TECHNICAL NOTE 1: Highways Consultation Response

DATE:	18 December 2023	CONFIDENTIALITY:	Public
SUBJECT:	Information to address highways consultation response		
PROJECT:	NSCC, Twycross Zoo	AUTHOR:	JH
CHECKED:	HB	APPROVED:	JH

TITLE: PROPOSED ENTRANCE SWEEP PATH

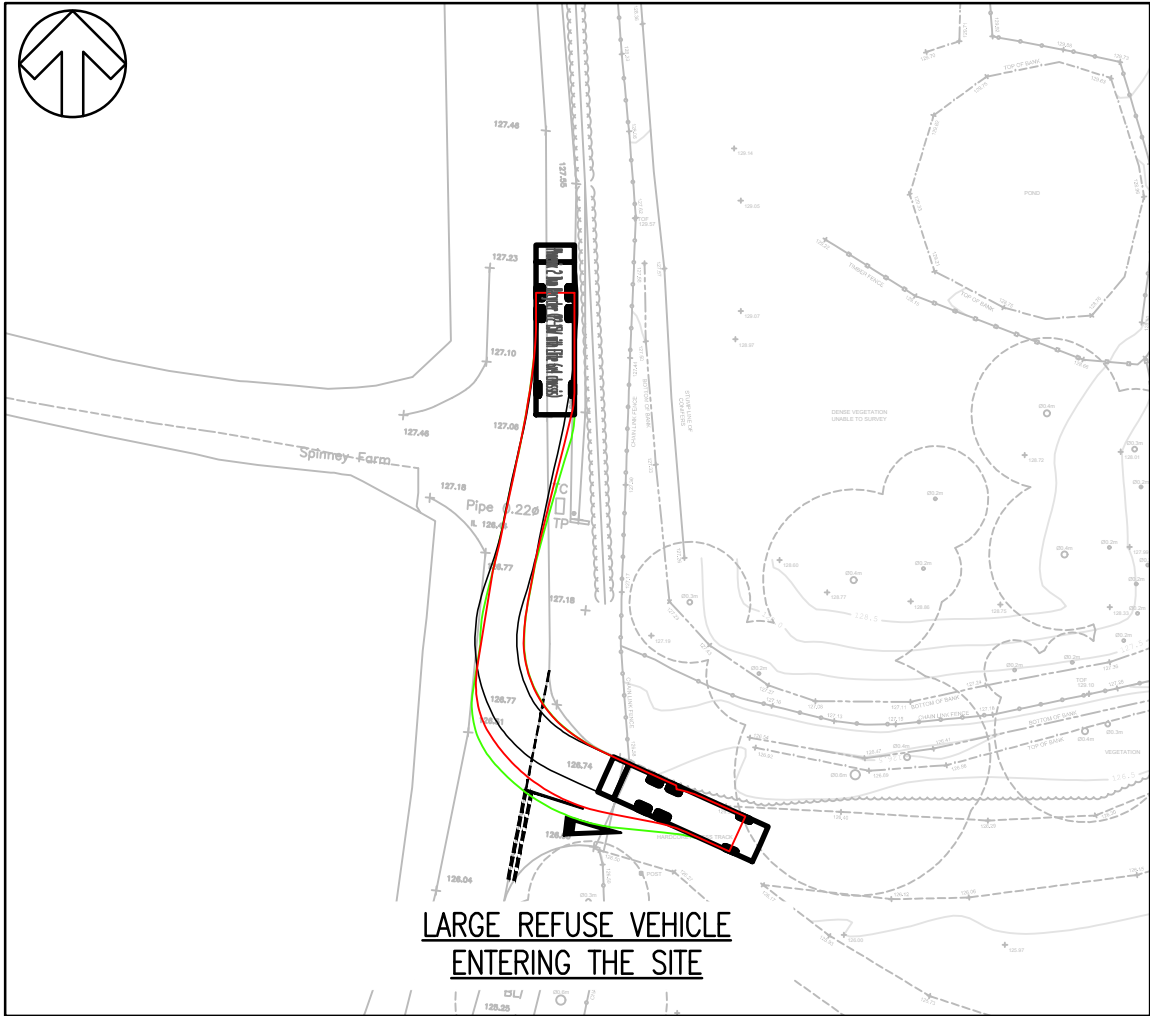
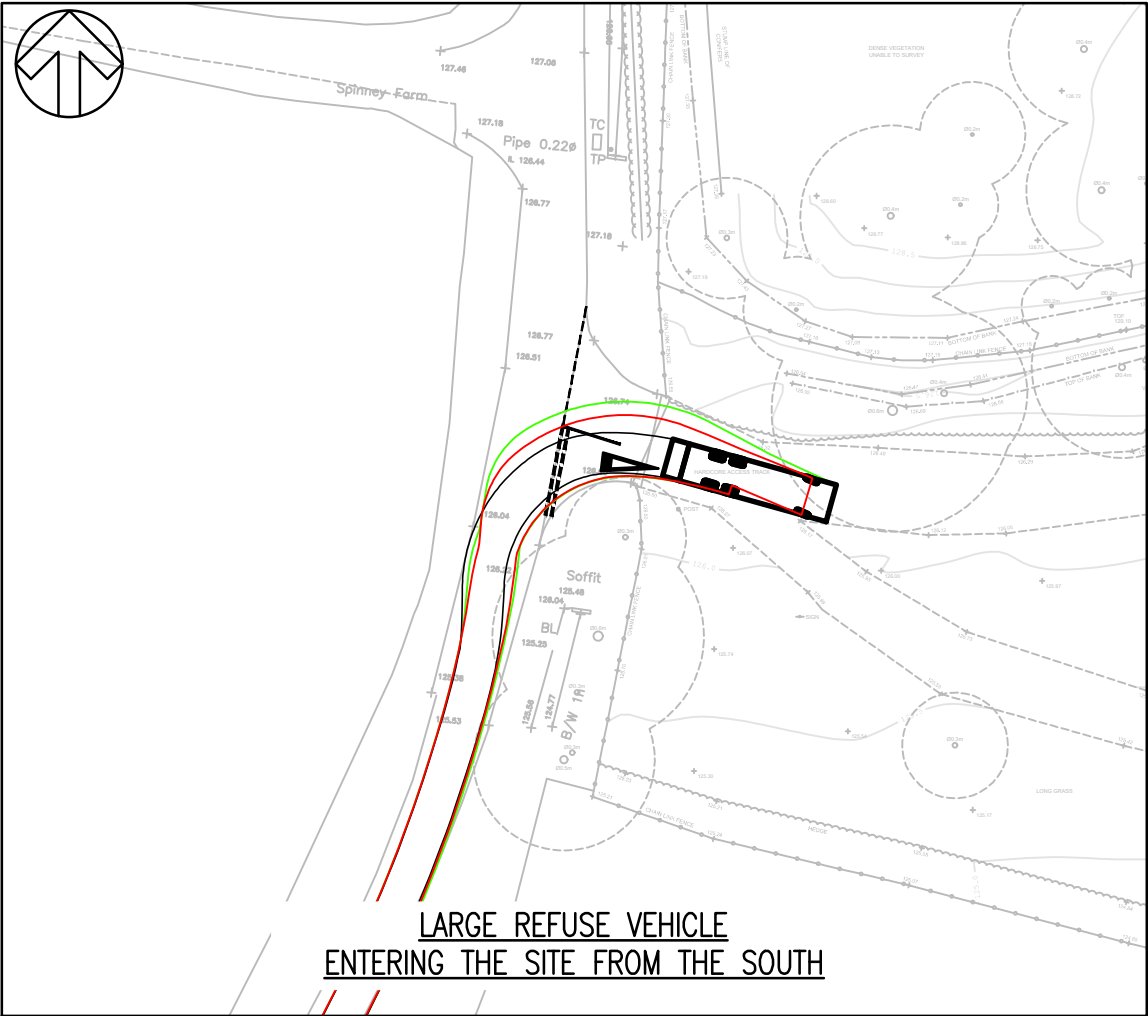
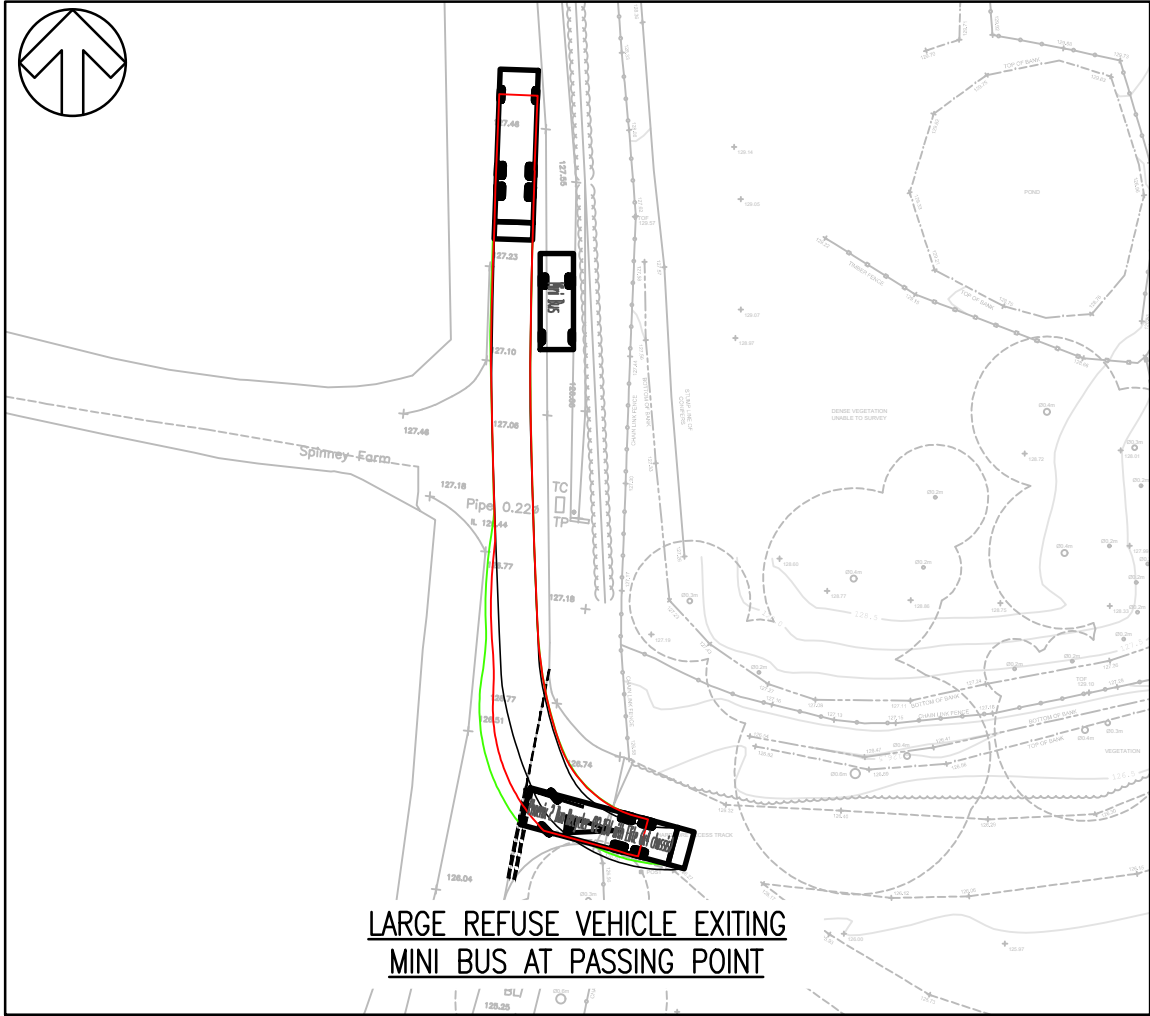
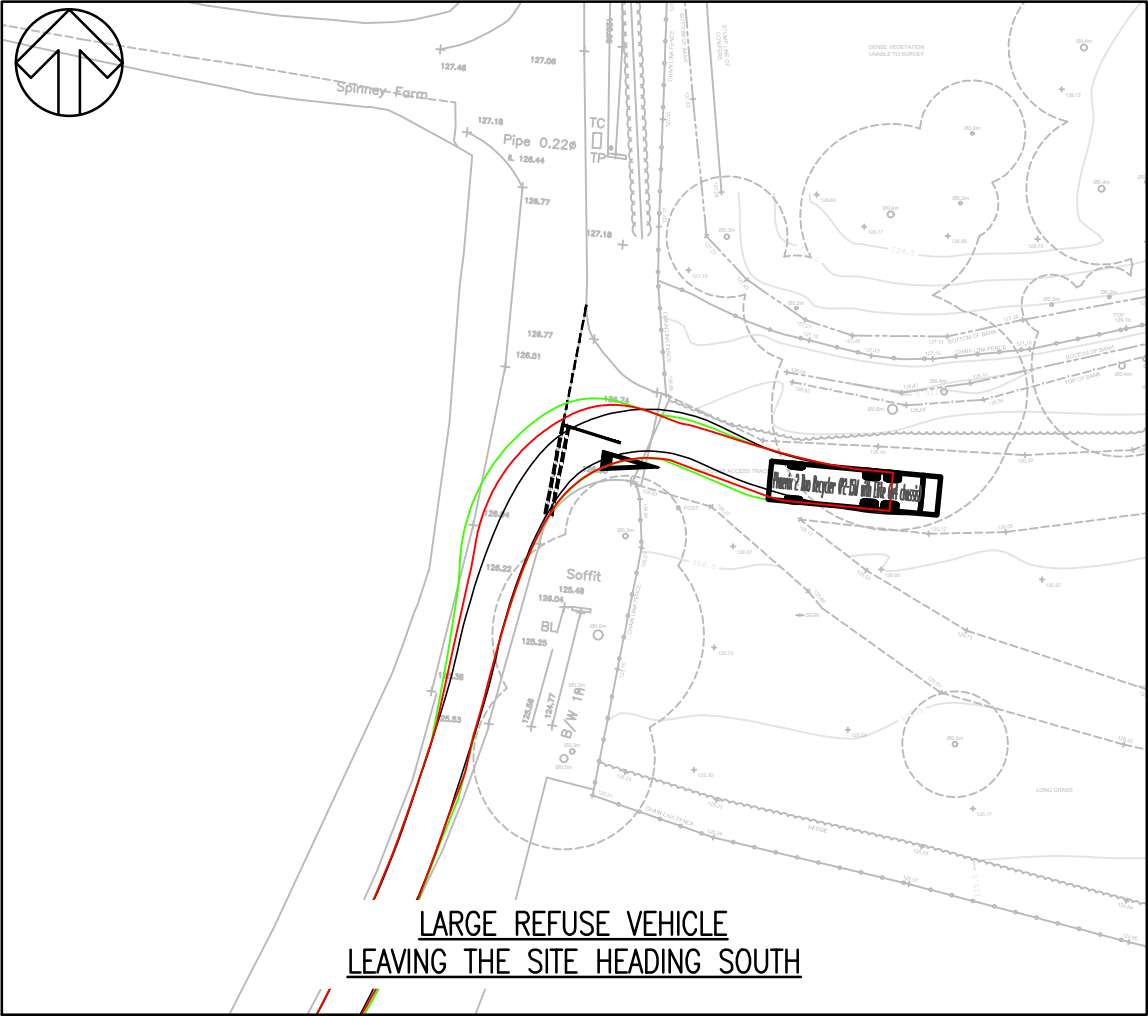
- Swept path analysis of a refuse collection vehicle and minibus turning right in/ left out of the Orton Hill access;
- A drawing detailing widening of the access and/ or carriageway and potentially increasing the junction radii of the access to accommodate refuse collection vehicles. A RSA1 and designers response (if necessary) would need to accommodate any proposed works; and
- Further clarification in respect of trip generation and how the site would operate, particularly the classrooms and lecture theatre, as well as the opening hours.

An updated swept path drawing showing a refuse vehicle turning into and out of the access to/from the south, as well as to/from the north, accompanies this note. As can be seen, the manoeuvre by this worst-case vehicle can be accommodated within the existing space available.

Given that the worst-case vehicle can be accommodated turning into and out of the site from and to the south and the north, it is not necessary to undertake any widening works. As no works are necessary or proposed, no RSA would be required.
